Council Reference: A006721031
Attention: Shirley Mills

RE: Response to Information Request – Multiple Dwelling & Food and Drink Outlet at 299 Coronation Drive, Milton

Figure 1: Extract of Sheet 5 and the Amendments to Facades Which Have Been Made – Plus Studio (March 2026)

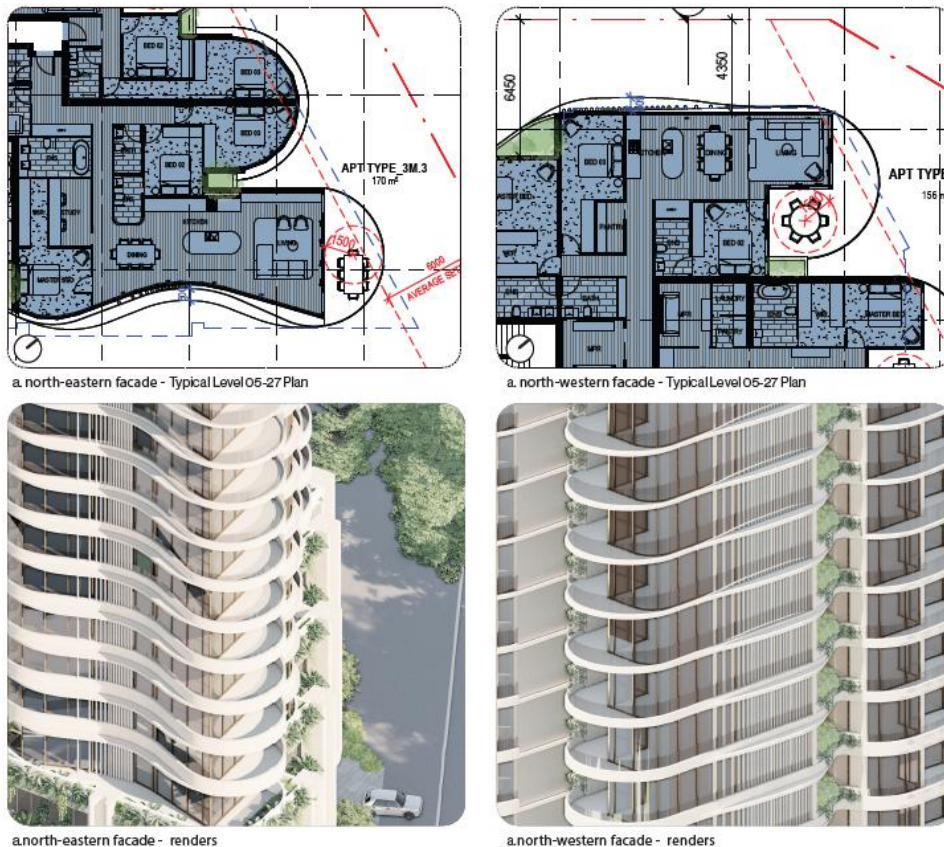
2. It is noted that a greater extent of the facade is afforded varying degrees of shading and the individual units now include more operable facade components to support cross flow ventilation and a better outdoor lifestyle. Notwithstanding, some parts of the tower facade require further improvement to ensure facade elements are sufficiently shaded to allow for a genuine reduction in the need for mechanical cooling. This is particularly true for the northeastern and north-western facing facades, though there is some concern with the limited extent of shading afforded to the south-eastern facing (Milton Road Elevation) facade.
- a) Provide amended plans to increase the extent of shading to reduce heat build-up on facades.

As outlined on page 5 of the revised Proposal Plans prepared by Plus Studio, adjustments to the projecting slab edges at the north-eastern and north-western corners of the facades have been made. As noted, the slab protrusion has been increased by 600mm, thereby increasing the shading benefit and link to heat load to these facades.

Figure 4: Extract of Colliers Swept Path Analysis for LRV – Colliers (26 March 2026)

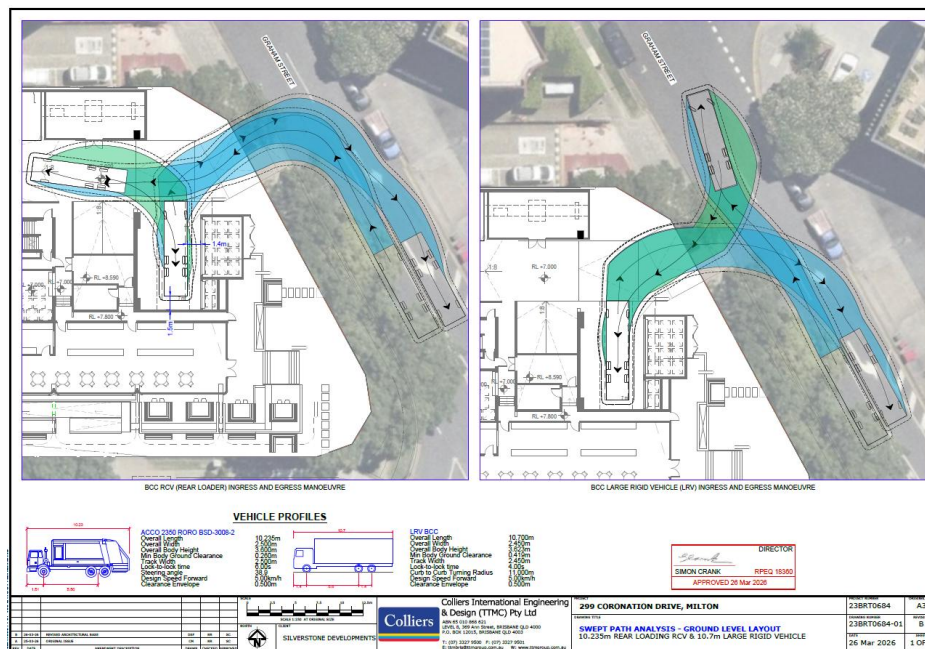
11. The proposed LRV swept path plan appears to show a conflict between the manoeuvring path and existing on-street parking areas.
- a) Submit a revised LRV swept path plan prepared by an RPEQ showing no conflicts with existing on-street car parking areas in accordance with PO3 and PO18 of the TAPS code.

A detailed response has been provided by Colliers, which accompanies this response. Drawing 23BRT0684-01 within Attachment B of the provided response includes swept path analysis which demonstrates and LRV can manoeuvre in and out of the site in forward gear.

Figure 5: Extract of Proposed of Bike Store Entryway – Plus Studio (March 2026)

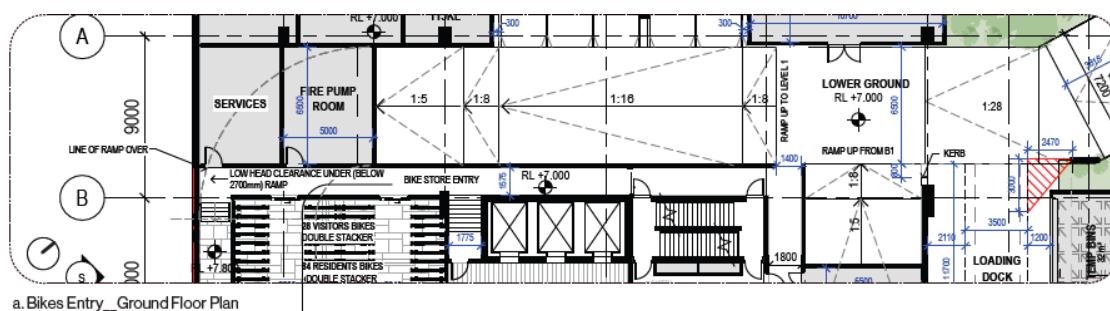
12. The proposed plans appear to show doorway and corridor areas which do not maintain a minimum accessway width of 1.5m through the site to bicycle parking areas as required by the PO4 and PO5 of the TAPS code and AS2890.3:2015 Figure 2.4 (for low volume/constrained areas).
- a) Submit revised plans showing a minimum access width of 1.5m as required by PO4 and PO5 of the TAPS code and AS2890.3:2015 Figure 2.4. It is recommended that doors which are required to be accessed by cyclists are amended to sliding doors to improve accessibility.

As detailed on the revised Proposal Plans the bike store accessway has increased in width to 1.575m, see plan extract below.

Bike entryway is widened to be greater than 1.5m

Figure 6: Extract of Proposed Refuse Storage Areas – Plus Studio (March 2026)

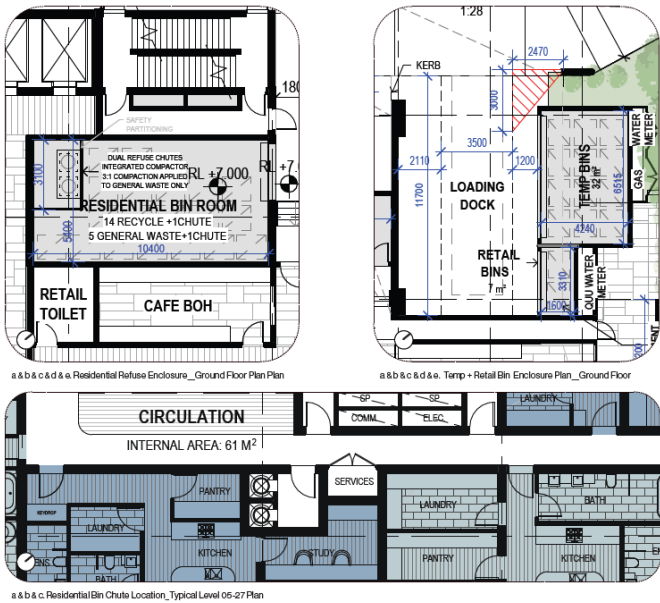
13. It is noted that the 'Loading Dock' contains a 'Dual refuse chute integrated compactor 3:1 compaction applied to general waste only', a separate 'retail bins' enclosure, with residential 'Temp Bins' refuse enclosures located on either side of the RCV loading bay. The design of the residential refuse enclosures containing the twelve (12) x 1,100L bulk bins, 'dual refuse chute' enclosure, residential refuse enclosure and retail refuse enclosure each containing two (2) x 1,100L bulk bins are not functional, with insufficient width provided between door openings for the required number of bins to be stored or additional space provided to enable circulation/manoeuvring of bins.

- a) Show the 'residential' refuse enclosure containing the twelve (12) x 1,100L bulk bins has been increased in size and provided with a minimum GFA of 24.45m² (internal dimension of 5.34m wide x 4.58m deep) to house twelve (12) x 1,100L bins, with additional space for manoeuvring of bins during servicing.
- b) Show the 'residential' dual refuse chute, residential refuse and 'retail' refuse enclosures which each contain two (2) x 1,100L bulk bins have been provided with a minimum width between the door opening of 3.06m to enable both bins to be manoeuvred.
- c) Clearly label the location of the 'residential' refuse enclosures, 'residential' dual refuse chute, and retail refuse.
- d) Show the residential and retail refuse enclosures have been provided with roller doors or the like in lieu of swing doors, given the available space

e) Ensure the GFA and internal dimensions of the residential refuse and retail refuse enclosures have been annotated on the amended plans.

- The residential bin store and compaction unit have been redesigned and relocated to be more centrally located within the core of the ground floor and consists of a total area of 54m²;
- All bin store areas are now appropriately labelled;
- All refuse storage areas have incorporated roller doors in place of swing doors; and
- Internal dimensions and gross floor area for refuse areas has been provided.
